TECHNICAL SERVICE BULLETIN

Classification: AT22-015A	Reference: NTB22-099A	Date: December 20, 2022
------------------------------	--------------------------	----------------------------

VIBRATION DURING LIGHT OR MODERATE THROTTLE INPUT

Figure 1

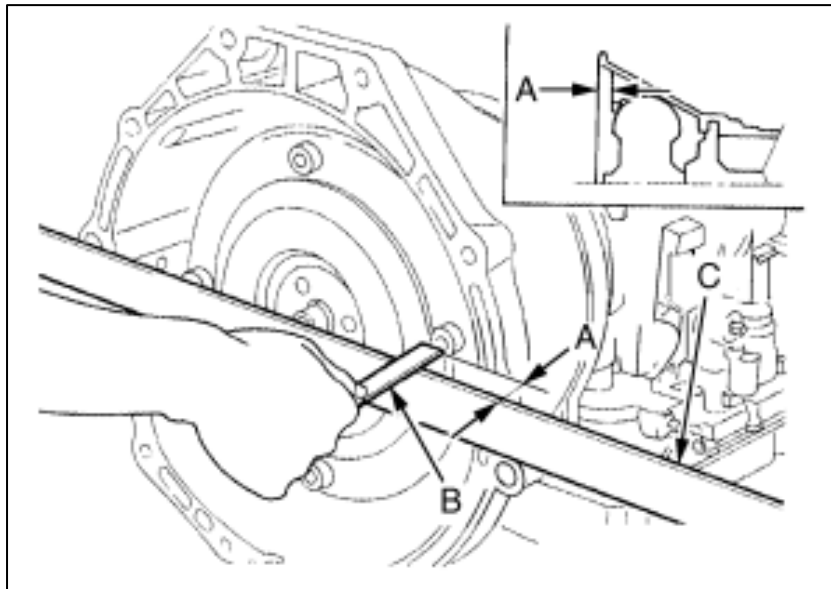
- Be sure to install a new input shaft O-ring when replacing the Torque Converter.
- After installing the Torque Converter into the transmission assembly, check dimension (A) before installing the transmission assembly in the vehicle.
 - (A): Dimension between the end of the converter housing and the Torque Converter 24.0 mm (**0.94 in.**).
